# Pioneer Casual Wear Ltd. (Extension)

## Structural Inspection Report

### Observation-01: Inadequate material test report, possible vertical and horizontal extension (Building C)

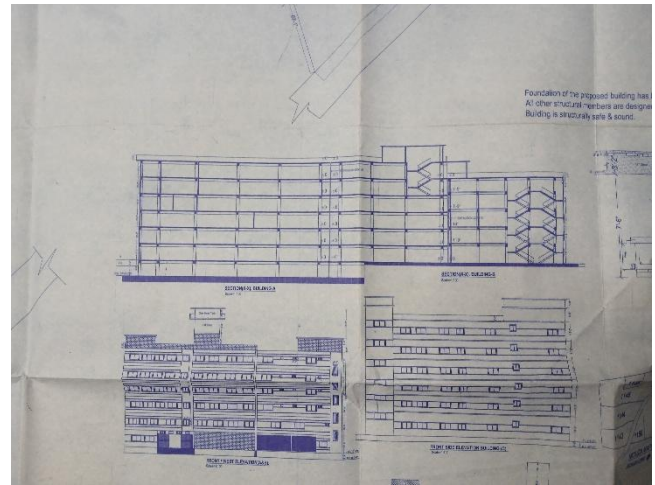
**Description:** During the inspection, the design report was found on-site, where concrete design strength was considered 4500 psi. 6 sets of cylinder test reports [Foundation = 3; Column = 1; Beam-Slab = 2] were available, which did not meet the frequency of testing requirements as per BNBC 2020. The building was approved for a 6-storied structure, and design documents were also prepared for 6-storied structures. The building engineer is required to address all the inconsistencies in the revised design report and submit them to RSC for detailed review.

| Item No | Observation                                                                              | Action Plan                                                                                                                                                       | Timeline        |
|---------|------------------------------------------------------------------------------------------|-------------------------------------------------------------------------------------------------------------------------------------------------------------------|-----------------|
| 1.      | Inadequate material test report, possible vertical and horizontal extension (Building C) | The building engineer is required to verify in-situ concrete strength by taking 4 cores (minimum) from the ground floor columns and beams confirm rebar strength. | within 6 weeks  |
| 2.      |                                                                                          | The building engineer is required to revise the design report and submit it to RSC for review.                                                                    | within 6 months |
| 3.      |                                                                                          | Prepare a design report considering the proposed extension prior to any future extension work                                                                     | within 6 weeks  |
| 4.      |                                                                                          | Implement remediation work (if required) after acceptance from RSC.                                                                                               | within 6 months |
